Well Name: JACKSON B	Well Location: T17S / R30E / SEC 1 / SENW /	County or Parish/State: EDDY / NM
Well Number: 33	Type of Well: OIL WELL	Allottee or Tribe Name:
Lease Number: NMNM2747	Unit or CA Name:	Unit or CA Number:
US Well Number: 300152380700S1	Well Status: Oil Well Shut In	Operator: EOG RESOURCES INCORPORATED

Notice of Intent

Type of Submission: Notice of Intent	Type of Action Plug and Abandonment
Date Sundry Submitted: 01/25/2021	Time Sundry Submitted: 08:36
Date proposed operation will begin: 07/23/2021

PLUG AND ABANDONMENT CONDITIONS OF APPROVAL

Jackson B #33 Proposed

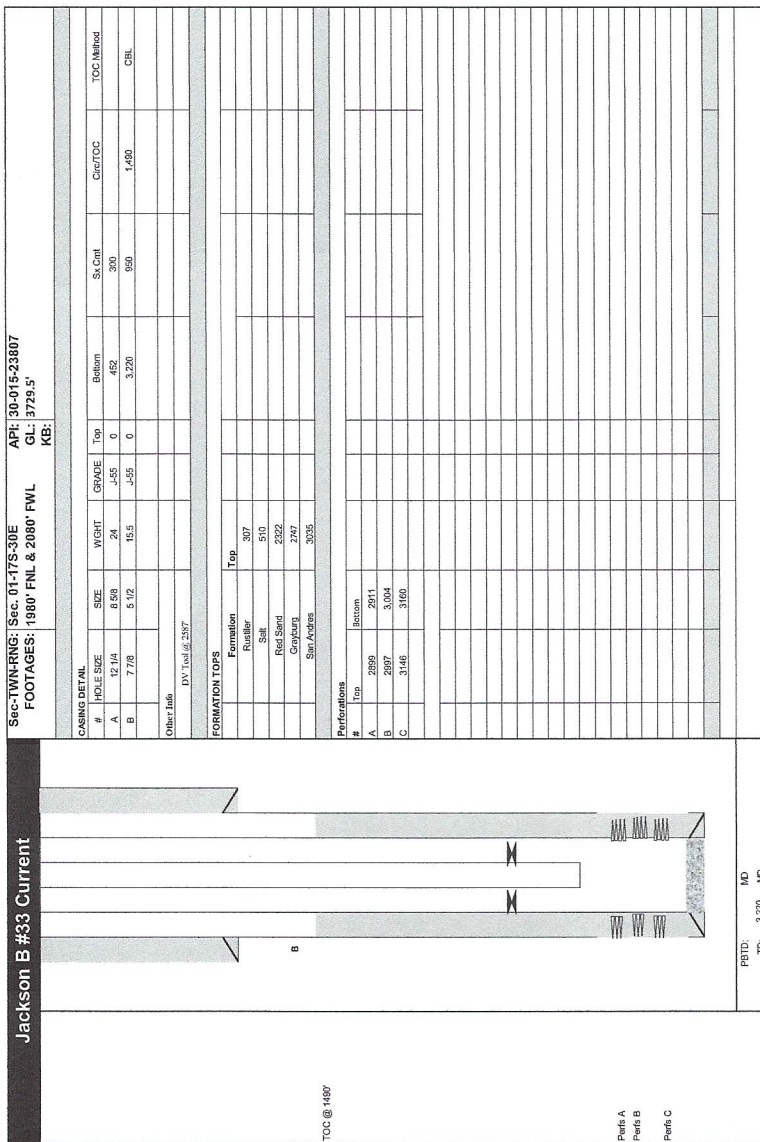
- MIRU all safety equipment as needed. NU BOP. POOH with production equipment.
- Set a CIBP at 3140 ft with 35 ft Class C cement on top to 3105 ft. This will cover San Andres. WOC and tag. *3140'*
- Set a 2nd CIBP at 2849 ft with 152 ft Class C cement on top to 2697 ft. This will cover top 25 sx class C Grayburg. WOC and tag.
- Perf & Spz. 30* Spot a 40 sx Class C cement plug from 1490 ft – 1380 ft. This will cover TOC on 5-1/2 inch casing. WOC & TAG. *1486' 1370' Leak test CIBP*
WOC and tag. *Base of salt @ 1436'* (In/out)
- Perf & Spz.* Spot a 48 sx Class C cement plug from 550 ft – 400 ft. This will cover salt section and 8-5/8 inch casing. WOC and tag. *560ft* (In/out) WOC & TAG
- Perf & Spz* Spot a 25 sx Class C cement plug from 100 ft up to surface. Back fill as needed. *Verify @ surface*
(In/out)
- Cut off wellhead and install dry hole marker. Clean location as per regulated.

→ Spot 25 sx class C @ 2590 - 2490 . DV @ 2540'
